The Landings, Ford Airfield

Phase RM4 (South)

Waste Infrastructure
Technical Note

Report Ref: 2205771-R26

Figure 2: Noise levels due to Operations at the Grundon Site (Application Reference: WSCC/096/13/F and WSCC/027/18/F)

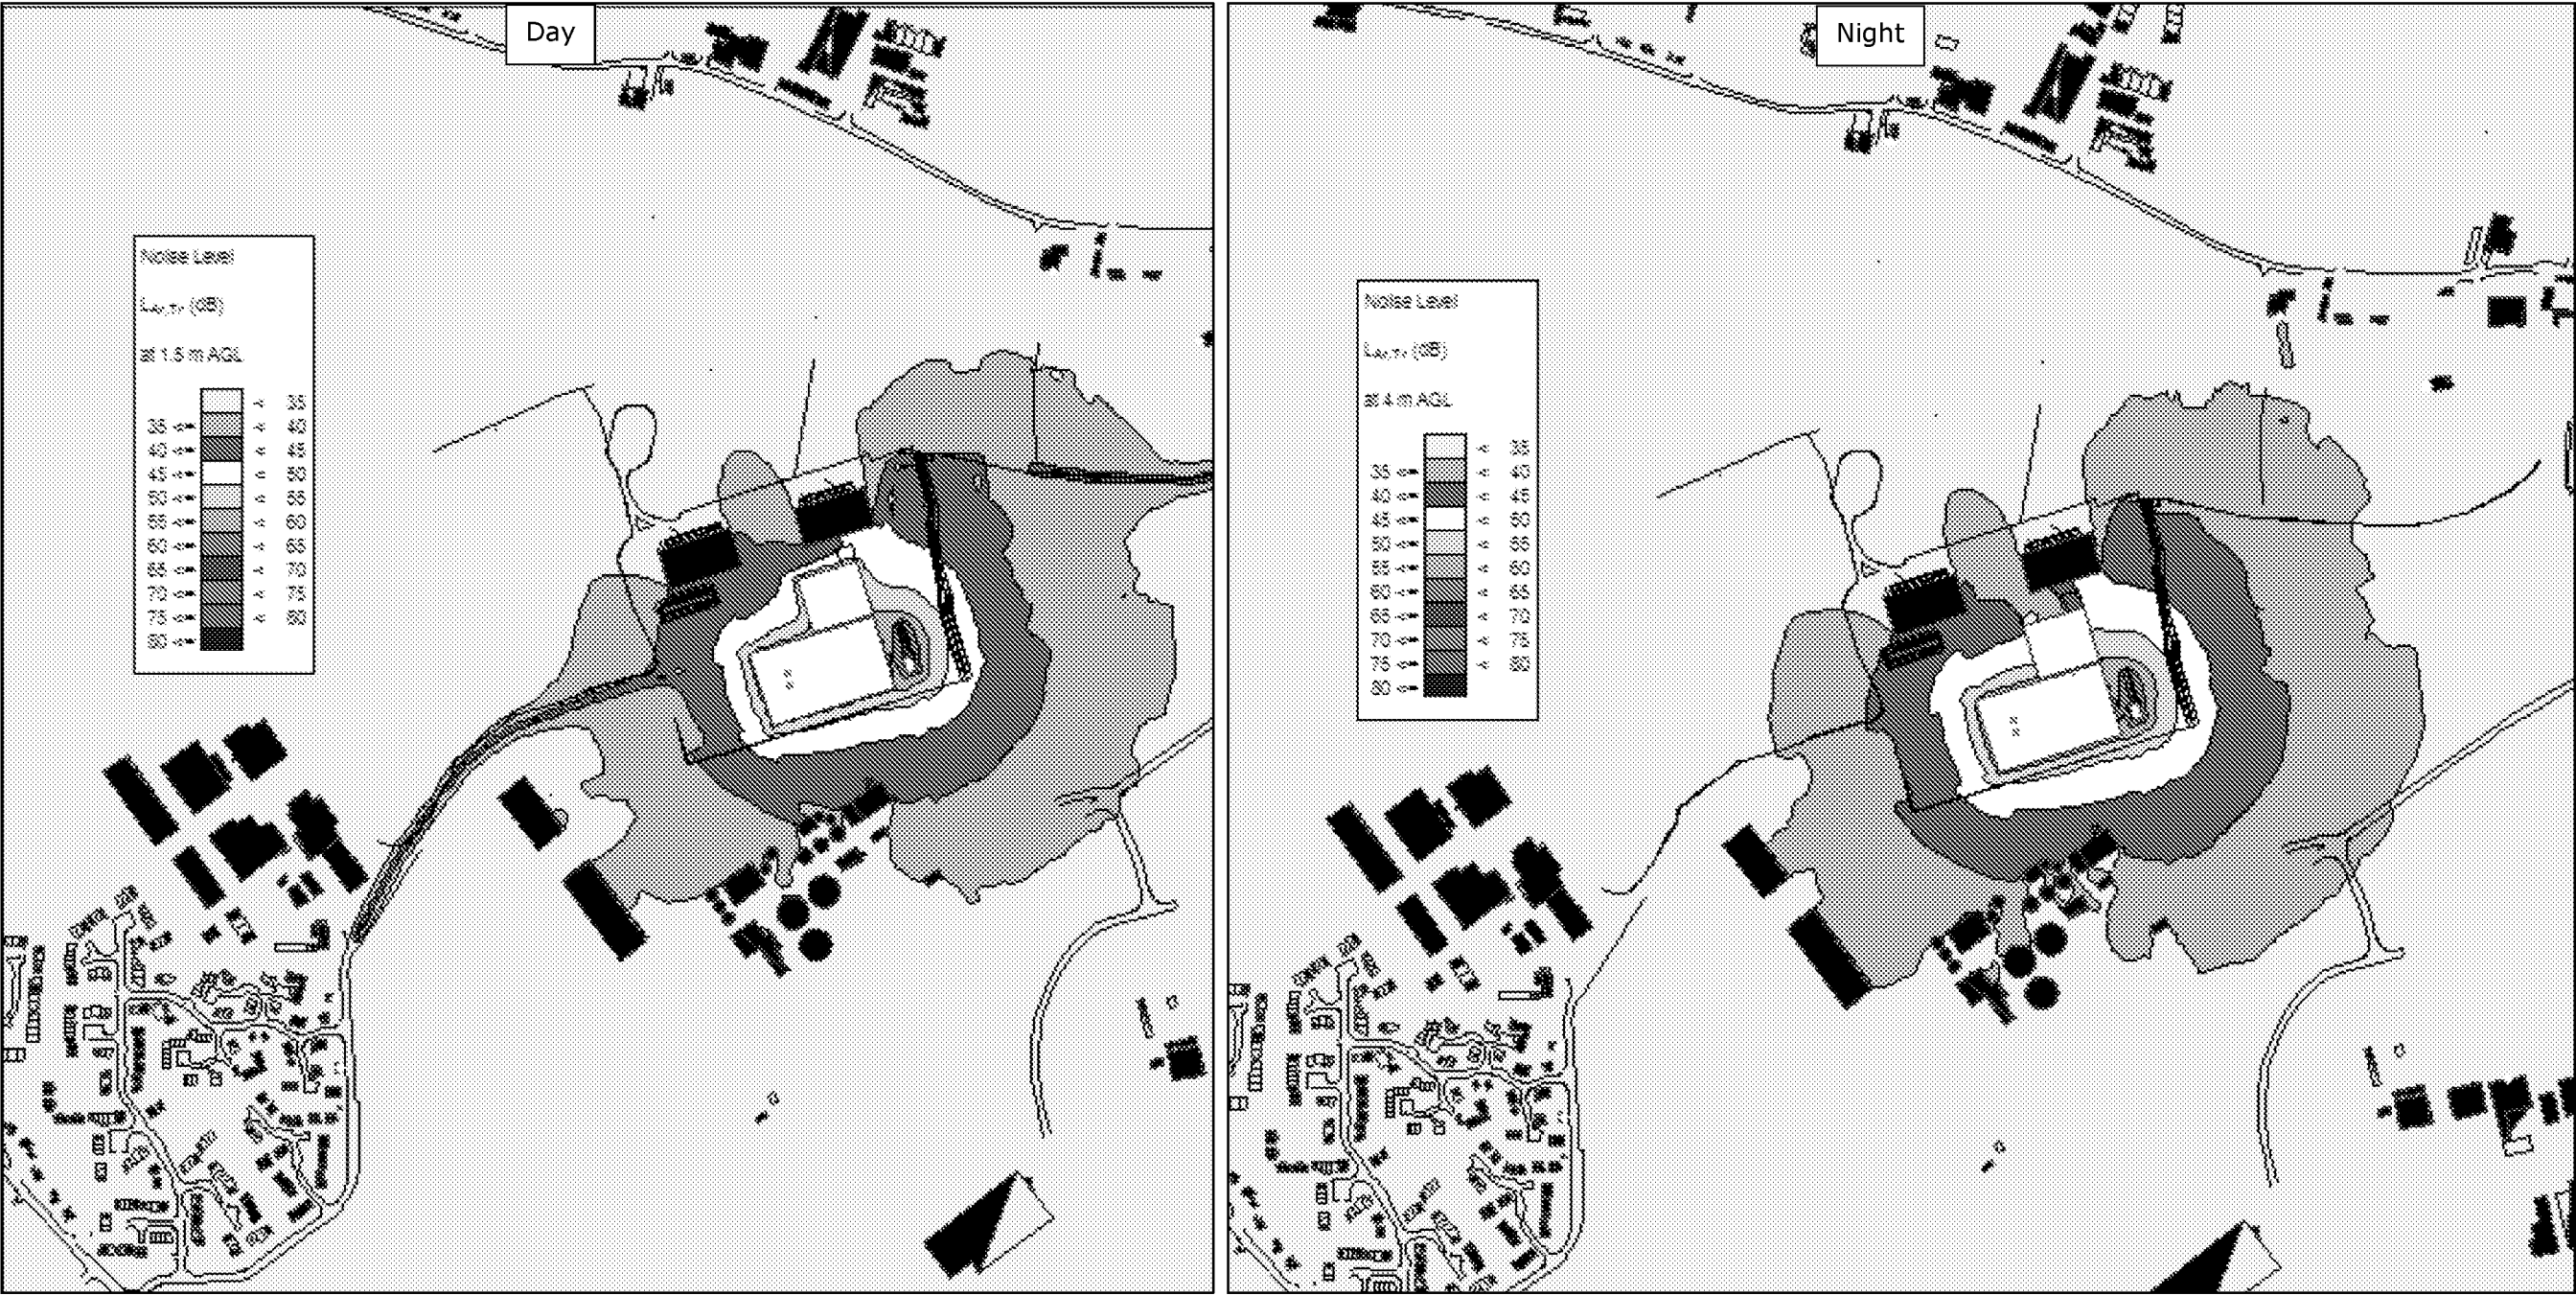
- 2.5. WSCC noted that the noise assessment does not demonstrate that noise from the Circular Technology Park/Grundon Waste Facility (Grundon) will meet the requirements of Condition 28 of the planning application for the facility, i.e., a rating level no greater than 35dB at the nearest sensitive receptors.

- WSCC/096/13/F: Circular Technology Park;
 - WSCC/027/18/F: Circular Technology Park;
 - WSCC/026/16/F: Wicks Farm;
 - WSCC/019/17/F: Wicks Farm;
- 2.7. The comments also note that noise levels from HD White (Ford Industrial Estate) would exceed the requirements of Condition 7, i.e. a rating level at the nearest sensitive receptors no greater than 5dB below the representative background sound level.

- 2.11. When a 3dB acoustic feature correction for impulsivity is applied to the noise levels at the nearest dwellings, the rating level due to operations at HD White will be 25dB $L_{A_r,Tr}$, which equates to 14dB below the representative background sound level. When a 3dB acoustic feature correction for impulsivity is applied to the noise levels at the nearest dwellings, the rating level noise level due to operations at Grundon will be 34dB $L_{A_r,Tr}$.

- 2.12. The noise assessment which accompanied the planning application for the Grundon Site shows the modelled noise levels with the proposed future operations, an extract from the noise modelling is shown below in Figure 2. Based on the noise modelling, noise levels are predicted to be significantly below 35dB $L_{A_r,Tr}$ at RM1 (North).

Figure 6: Proposed 4m High Noise Barrier Locations and Landscaping

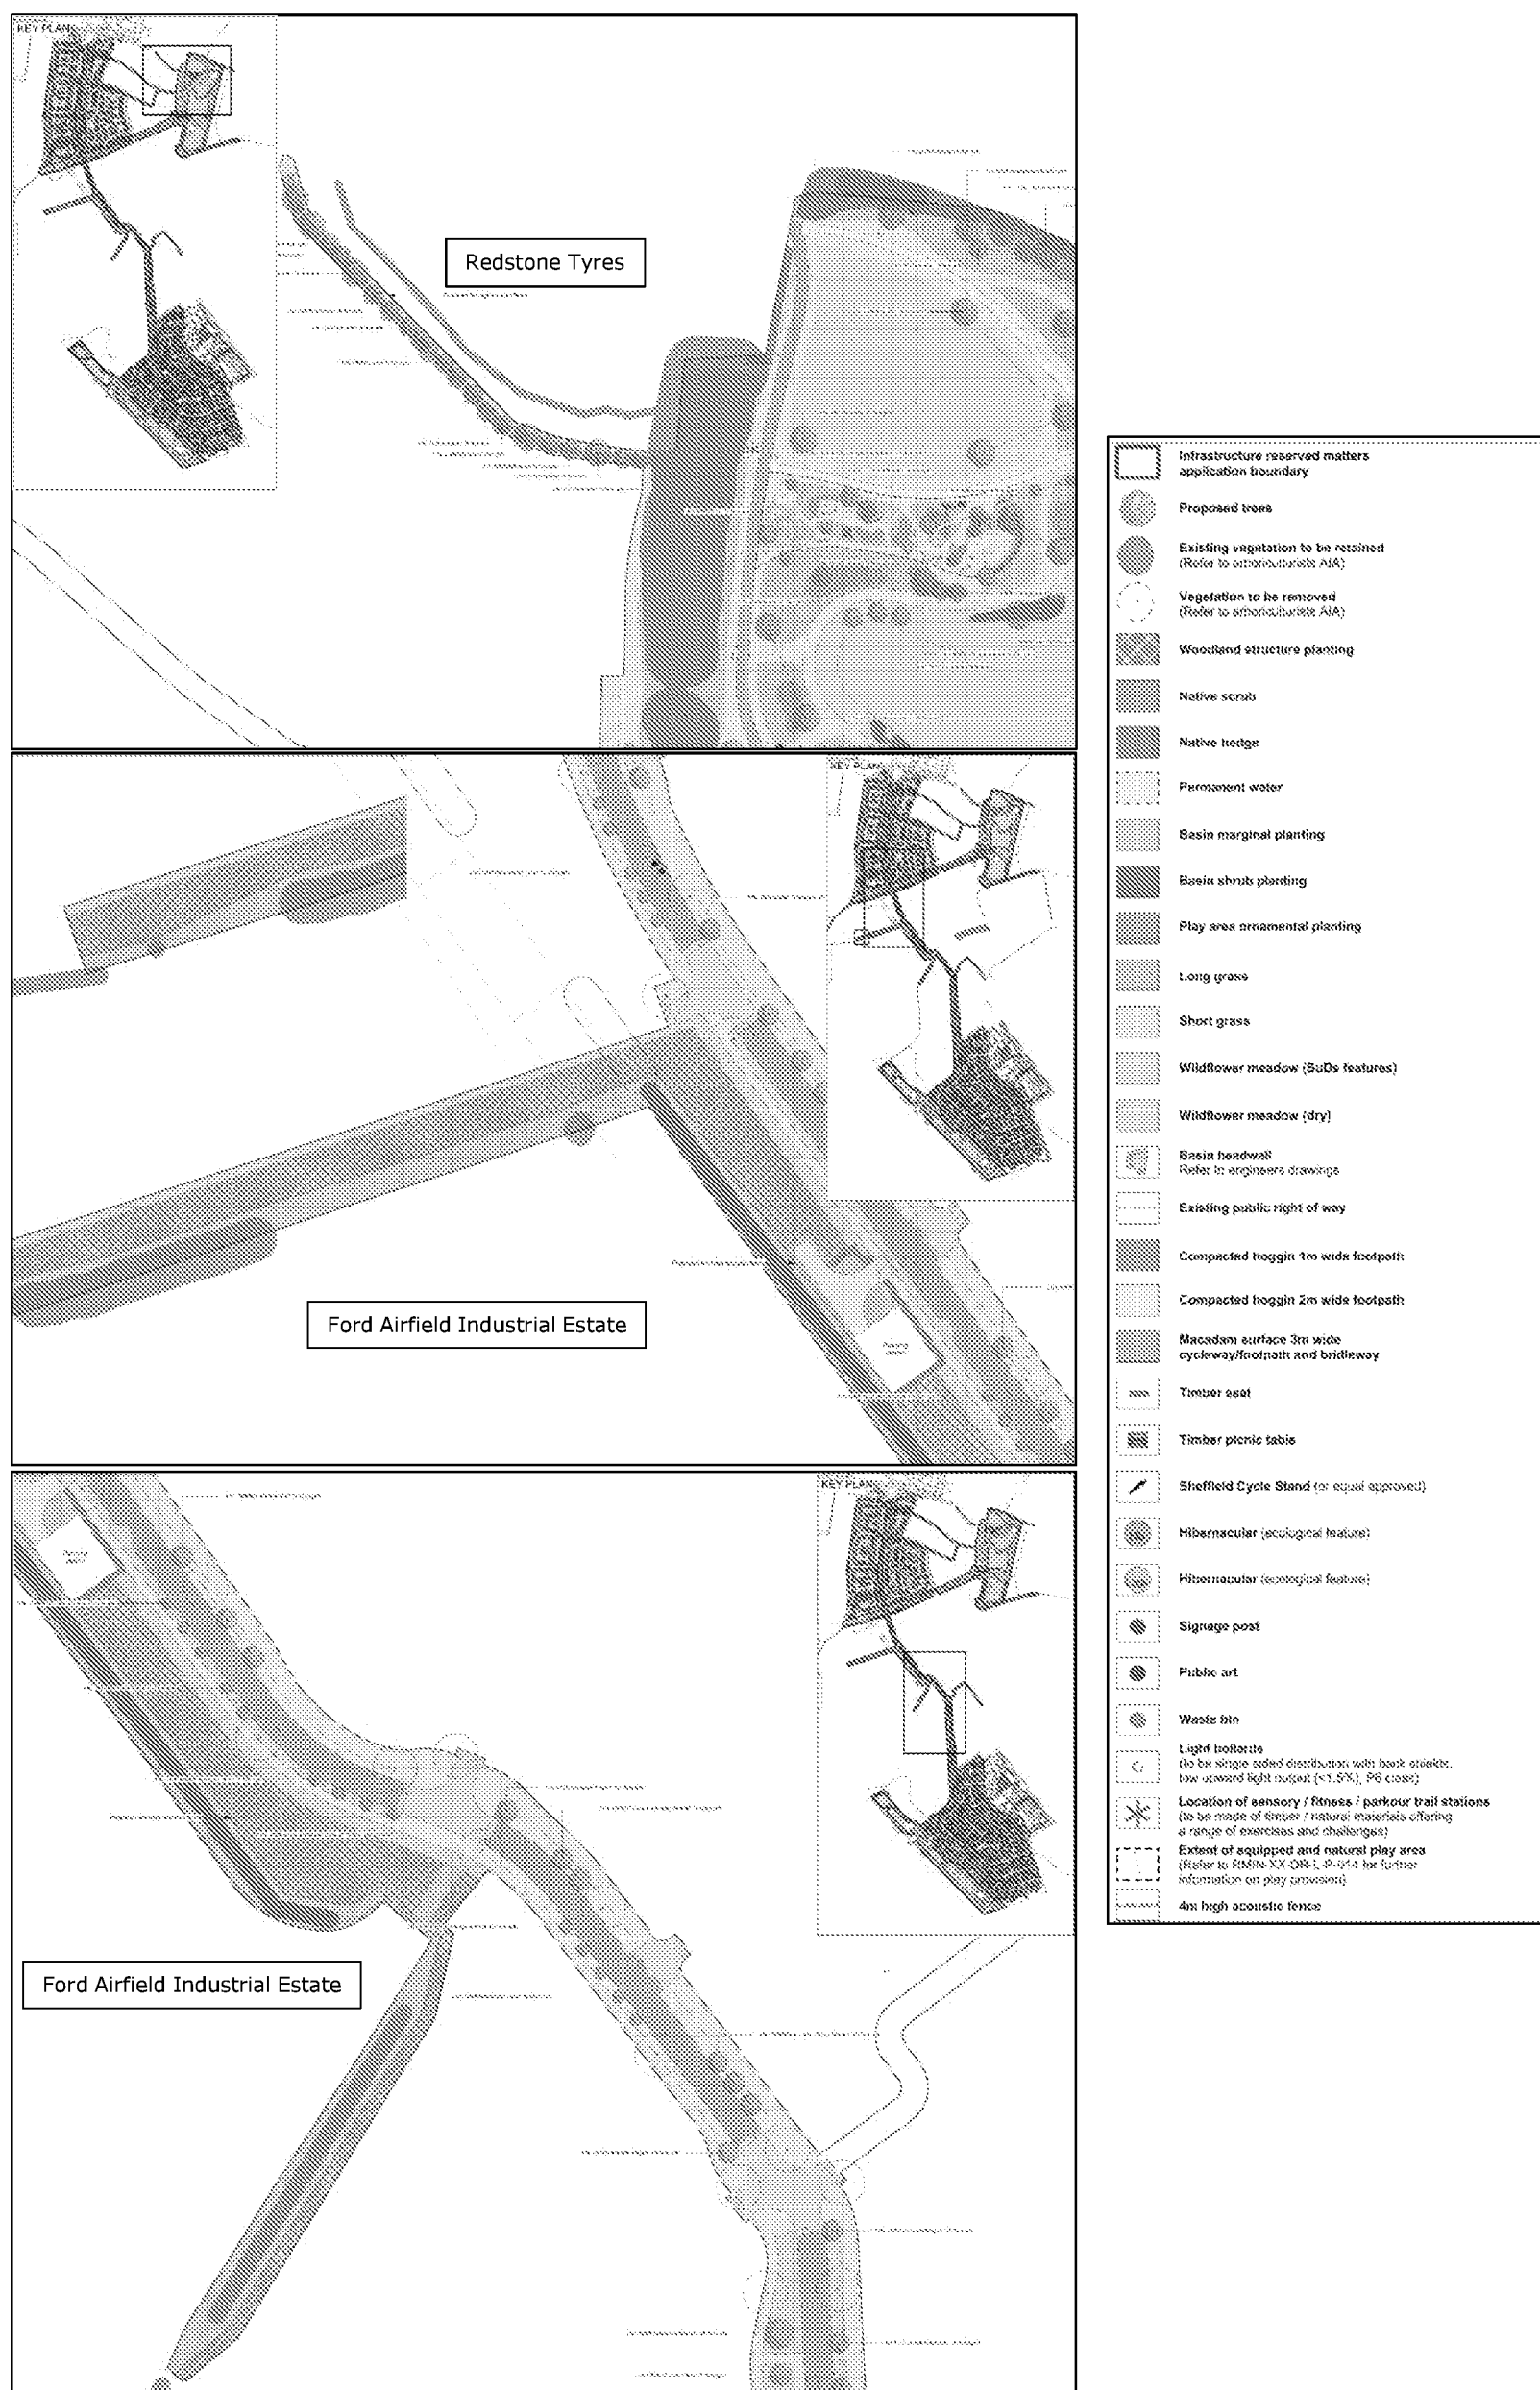
- 3.1. Officers at ADC have provided comments in relation to the infrastructure and RM1 (North) Reserved Matters planning applications.
- 3.2. The comments regarding the infrastructure Reserved Matters planning application noted that further details of the noise mitigation measures to provide suitable internal and external amenity sound levels at the site needed to be provided to support the discharge of Condition 25.

- 4.4. The locations of the 4m high noise barriers are shown in the primary street drawings which accompany the infrastructure Reserved Matters planning application. Structural woodland planting, basin shrub planting and trees are proposed, which will reduce the visual impact of the barriers. An extract of the drawings is shown in Figure 6.

- 4.5. A number of heights have been tested and the results of the noise modelling identify that a barrier height of 4m provides the best possible reduction in noise levels, whilst also taking into account other design considerations, such as landscaping and arboriculture. Taller structures would provide little additional acoustic benefit and would have an increased visual impact.
- 4.6. The results of the noise modelling with the proposed barriers is presented in Figure 7. The noise modelling presents noise from the Ford Airfield Industrial Estate and Redstone Tyres in isolation, to demonstrate the reduction in noise levels achieved by the noise barriers in relation to these operations.
